TECHNICAL SERVICE BULLETIN

1-F-6

TRIUMPH

Front Brake Calipers

The sketch on the reverse side shows the physical difference between the two calipers.

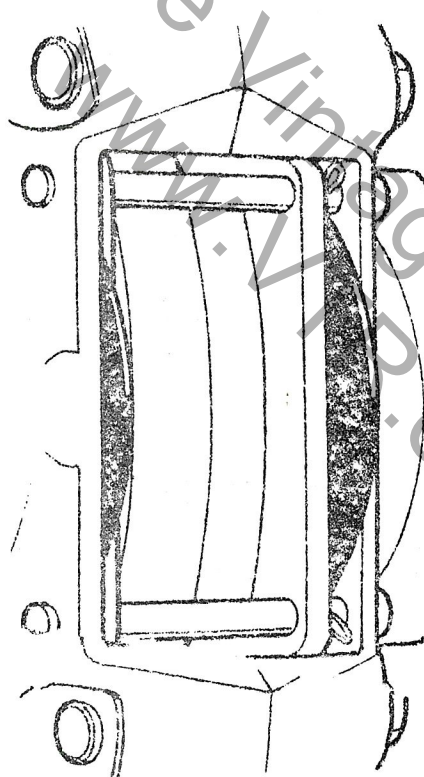
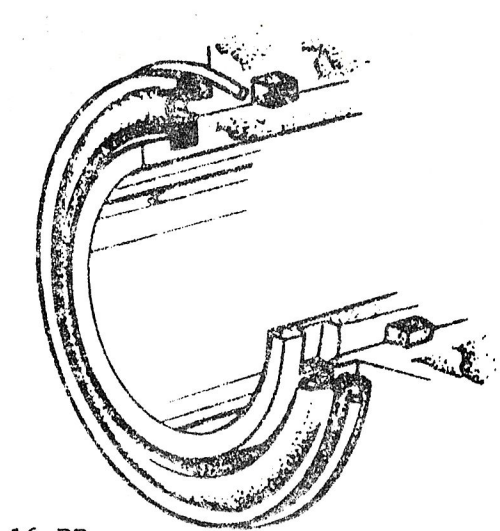
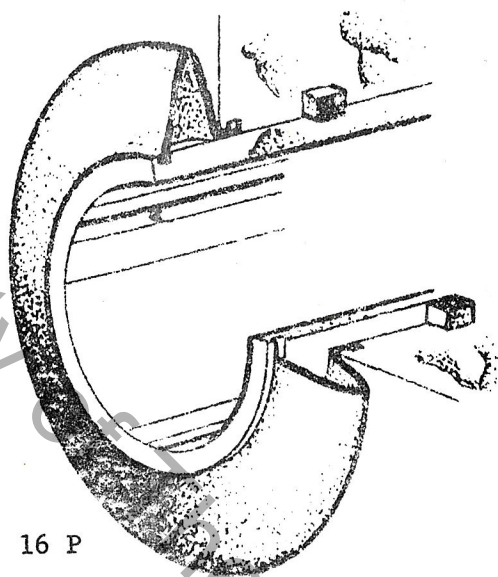
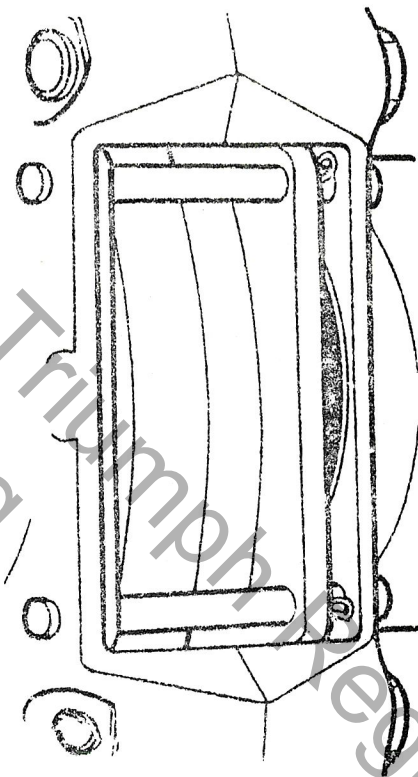
A new type of front brake caliper known as the "16 PB" has been introduced by Messrs. Girling to replace the existing "16 P" type.

These two calipers are interchangeable as an assembly, but care must be exercised when overhauling either units to insure that the correct repair kit is used. The appropriate part numbers are as follows:

"16 PB" Type. Repair kit to service one single caliper unit. # 519733.

"16 P" Type. Repair kit to service one single caliper unit. # 519732.
